Committee Room Corridor

PROJECT / DRAWING TITLE  
HORNSEY TOWN HALL  
TOWN HALL & BROADWAY ANNEX  
LONDON N8 9JJ

DRAWING TITLE  
TOWN HALL LOBBY STRUCTURE  
CINEMA PLATFORM LIFT & DOOR [D-01-23.24]  
@ CORRIDOR F.49

| PROJECT / DRAWING NO<br>3670-KDS-TH-01-DR-A-32-9715 |                  |           |

Door leaf only to be replicated for new doors

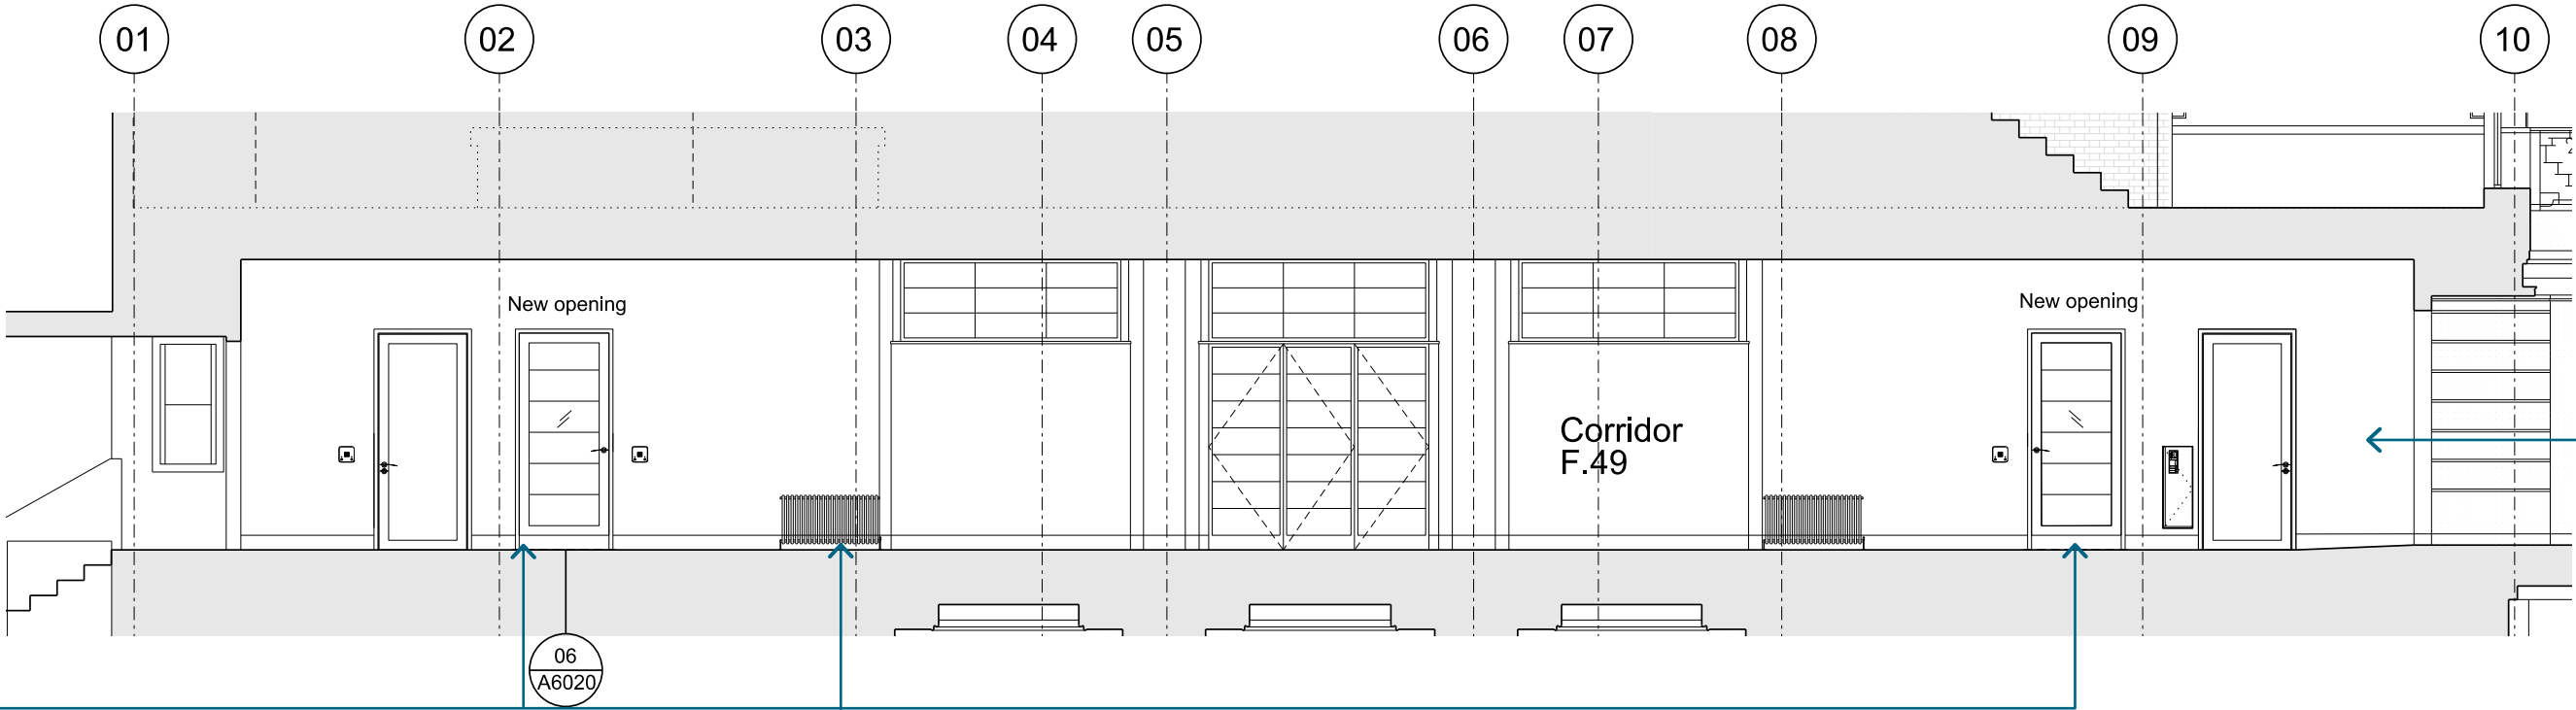
New doors have been added to the corridor for access to the existing stairs from foyer to cinema as part of the approved scheme. To allow for the level change between the existing stair core landing and corridor landing without extensive structural works a new timber threshold is installed aligned and matching the skirting. The leaf of the door is to replicate the existing reference door shown and is a timber door with glazing.

Internal Elevation

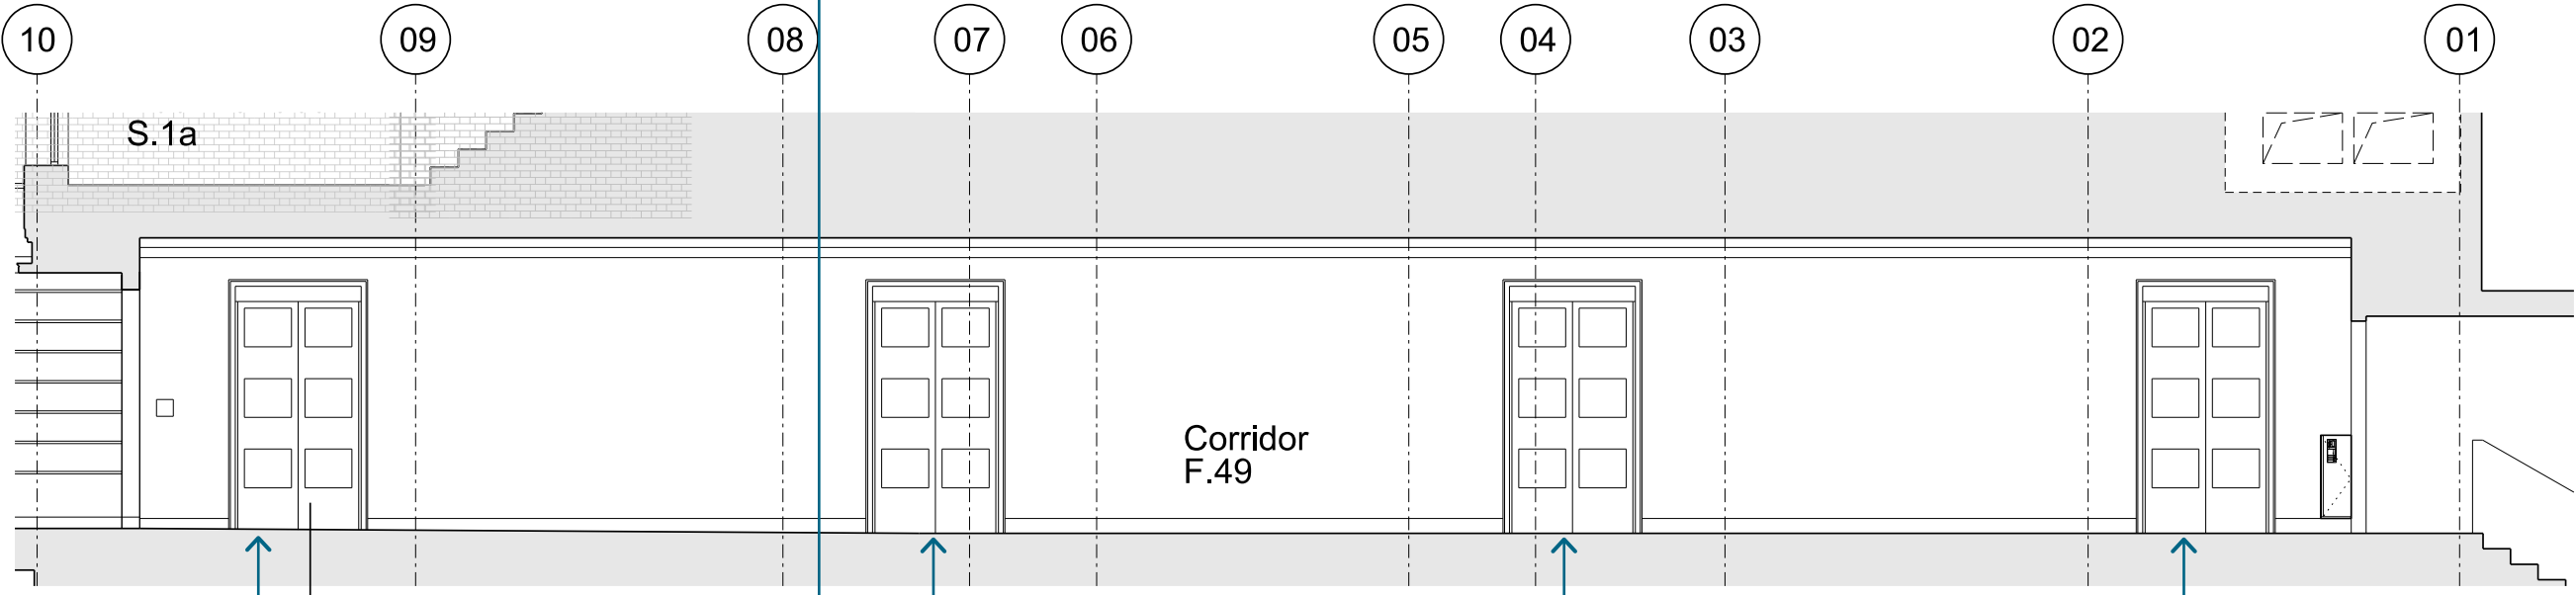
Existing committee doors to be refurbished and repaired - original door moved location relocated back to existing location. Fire test done on timer on other existing timber doors allowing for doors to not be replaced with fire rated replicas like initial proposal.

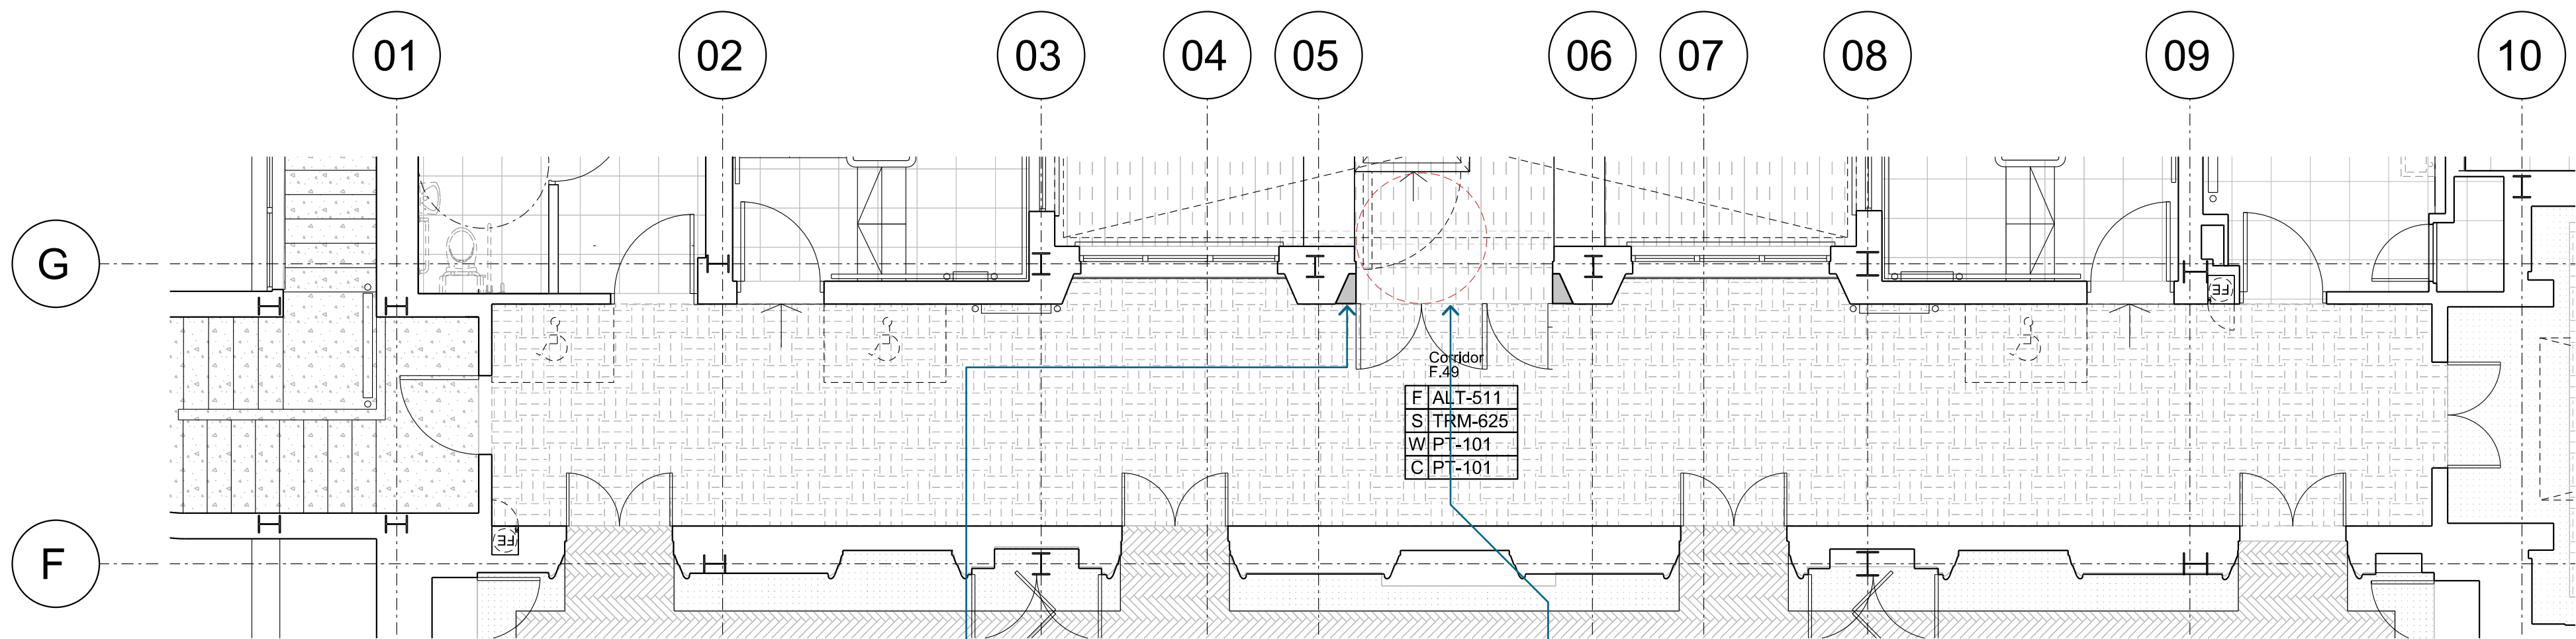
Existing plaster wall with signs of light wear and tear - to refurbished and repaired as the detailed method statements ALT-758

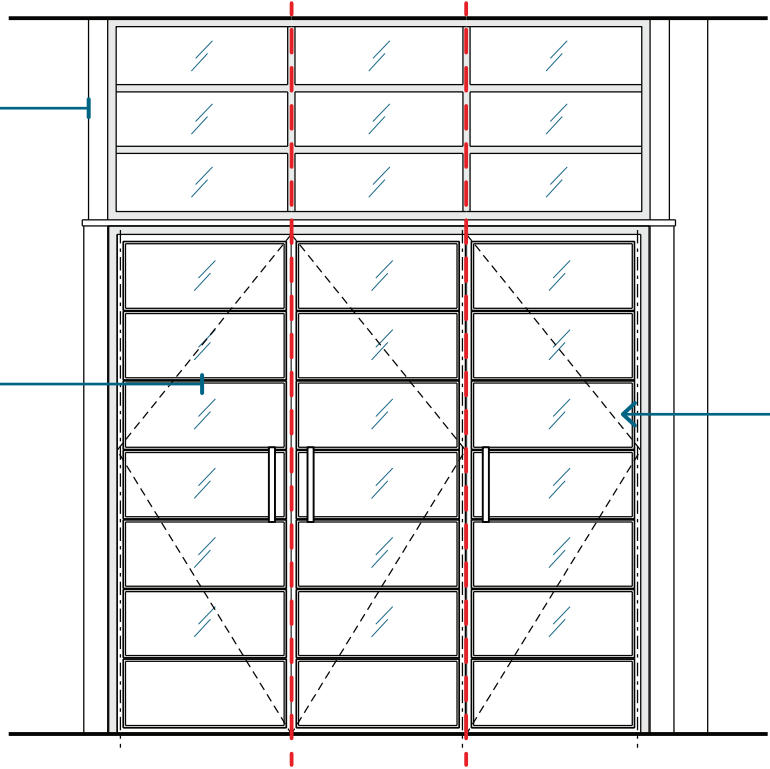
New door introduced to allow access to the cinema lift - in a variation the approved scheme the doors are to sit into the corridor, aligned with the face of existing columns, with these extended horizontally to meet the new door.

This is to allow for a turning circle in front of the lift as required by building control not viable within the approved scheme, as the lift cant push further into the cinema due to a clash with structure.

The door has be designed to match the proportions of the existing window above, with each leaf aligned to a bay. The design and structure of the doors is to match the metal glazed screens used elsewhere in the building

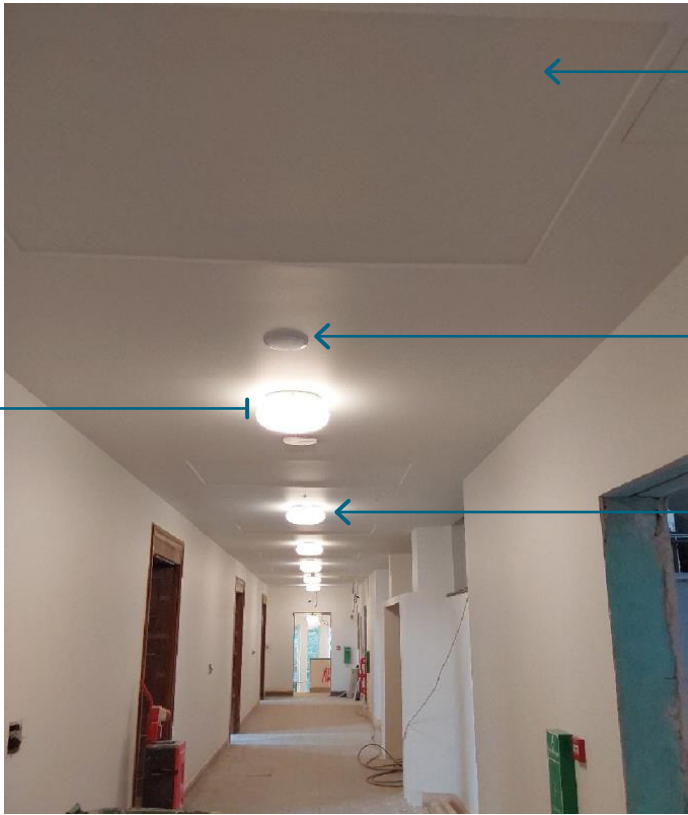
Existing radiant panels in ceiling to be removed to allow the instillation of services. To be reformed in plasterboard as insets to provide a reference to the original installation with matching trim. Original radiant panels maintained elsewhere in the building.

Radiant panels referenced in new plasterboard ceiling.
